Issues with 'PLCA sublayers' in the PAR scope and objectives related to clause 147 PHYs

G. ZIMMERMAN
CME CONSULTING
OCTOBER 1, 2026

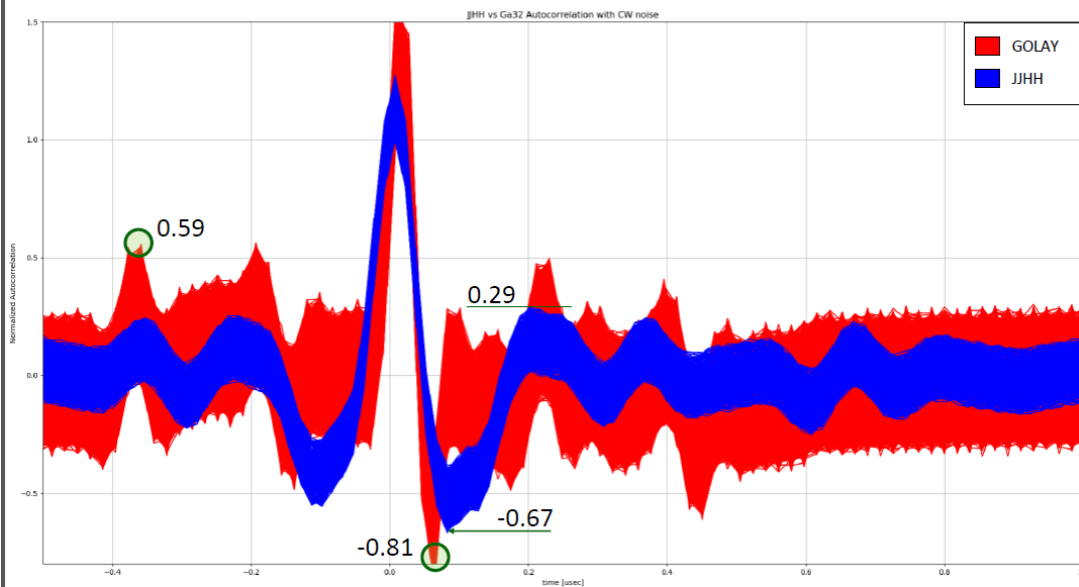
Beware adding new control encodings

Encodings outside an Ethernet frame (when TX_EN = FALSE) need to be distinguished from the SYNC encodings

- Not just a bit-error detection
- Must occur without clock sync
- Must be robust to noise and sufficiently different from cg

802.3cg analyzed the SYNC sequence carefully against the BEACON and COMMIT sequences for correlation properties

Correlation properties matter if we are adding signalling outside the Ethernet frame

Making sure BEACON can't be confused

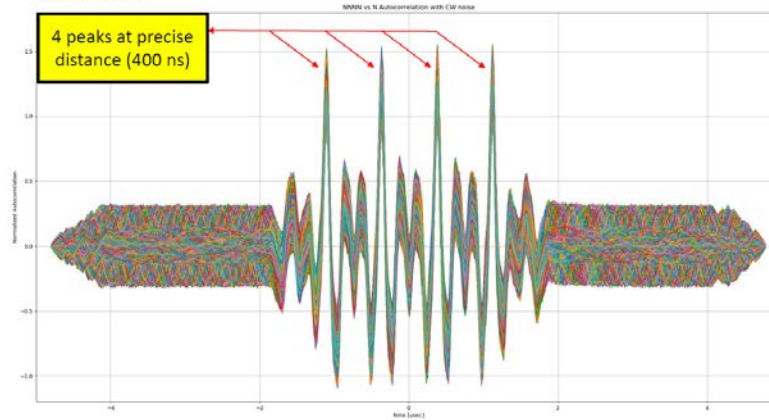
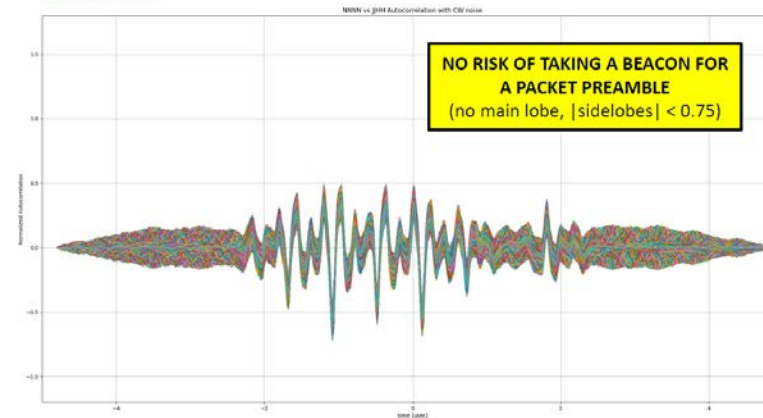
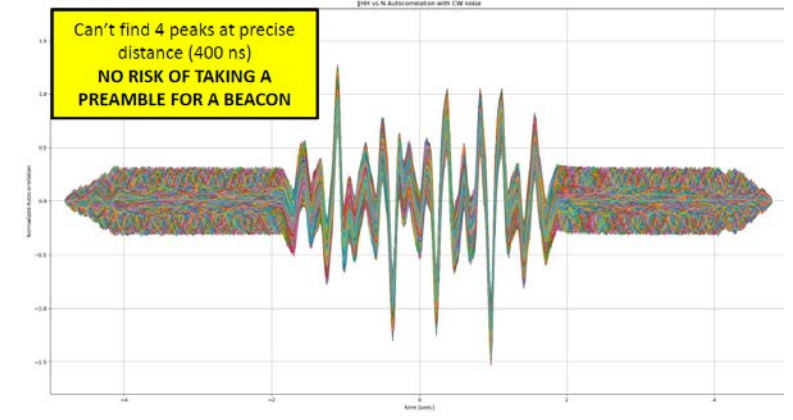
Adding a new signaling would change the PHY silicon's correlator

Requires analysis of all cross-correlation sequences, now more complex because there is another signal

Makes existing 10BASE-T1S/10BASE-T1M PMA/PCS silicon incompatible with the new solution (because it lacks the encoding)

Makes E-PLCA a “new PHY” project vs. a “physical layer” project that operates above the PHY (e.g., adding PLCA RS and control hooks.)

Is that what we really want? – IF SO, say it, if not – make it clear
